Work Order ID 89814

Item Name: Crosstube Mid Fwd

DART AEROSPACE LTD HAWKESBURY, ONTARIO, CANADA	
DRAWING NO. D206-667-147	REV. A SHEET 1 OF 4
TITLE CROSSTUBE ASS'Y (206L MID FWD)	SCALE NTS
COPYRIGHT © 2010 BY DART AEROSPACE LTD THIS DOCUMENT IS PRIVATE AND CONFIDENTIAL AND IS SUPPLIED ON THE EXPRESSED CONDITION THAT IT IS NOT TO BE USED FOR ANY PURPOSES OR COPIED OR REPRODUCED IN ANY FORM OR BY ANY MEANS WITHOUT WRITTEN PERMISSION FROM DART AEROSPACE LTD.

DRAWING NO. D206-667-147	TITLE CROSSTUBE ASS'Y (206L MID FWD)	REV. A	<b>DART AEROSPACE LTD ENGINEERING ORDER</b>		D.E.O. NO. D206-667-147-A-1	SHEET NO. SHEET 1 OF 1	SCALE NTS
DRAWN <i>90</i>	CHECKED <i>ASS</i>	MFG. APPR. <i>MB</i>	APPROVED <i>MD</i>	DE APPR. <i>MB</i>			
DATE 11.07.15	DATE 11.07.20	DATE 11.07.21	DATE 11/07/21	DATE 11.07.21

**DETAIL P**  
BONDING STRAP INSTALLATION 2 PL

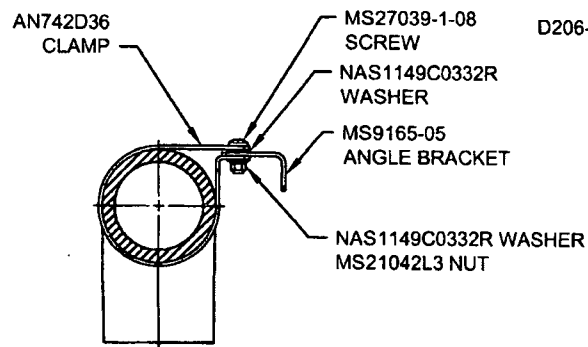
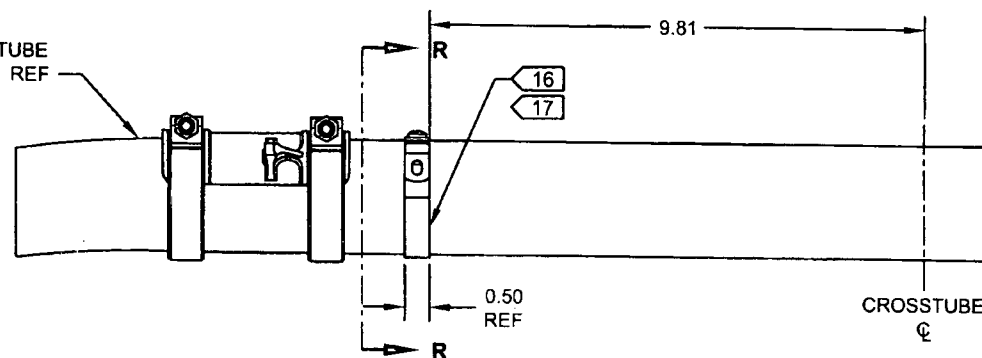
ADD ELECTRICAL GROUNDING STRAP

ITEM	QTY	PART NUMBER	DESCRIPTION
1	X	D206-667-147	CROSSTUBE ASSEMBLY (206L MID FWD)
10	2	AN742D36	CLAMP
11	2	MS9165-05	ANGLE BRACKET
12	2	MS21042L3	NUT (OR MS21042-3)
13	2	MS27039-1-08	SCREW
14	4	NAS1149C0332R	WASHER (OR AN960C10L)

- 16) MASK AREA UNDER CLAMP PRIOR TO PAINTING
- 17) SEAL EDGES WHERE AN742D36 CLAMP MEETS WITH THE CROSSTUBE USING SIKAFLEX-241/-291 OR MIL-S-8802 CLASS B2 OR PROSEAL 890 SEALANT
- 18) PERFORM RESISTANCE CHECK TO ENSURE MAX RESISTANCE IS 10 MILLIOHMS
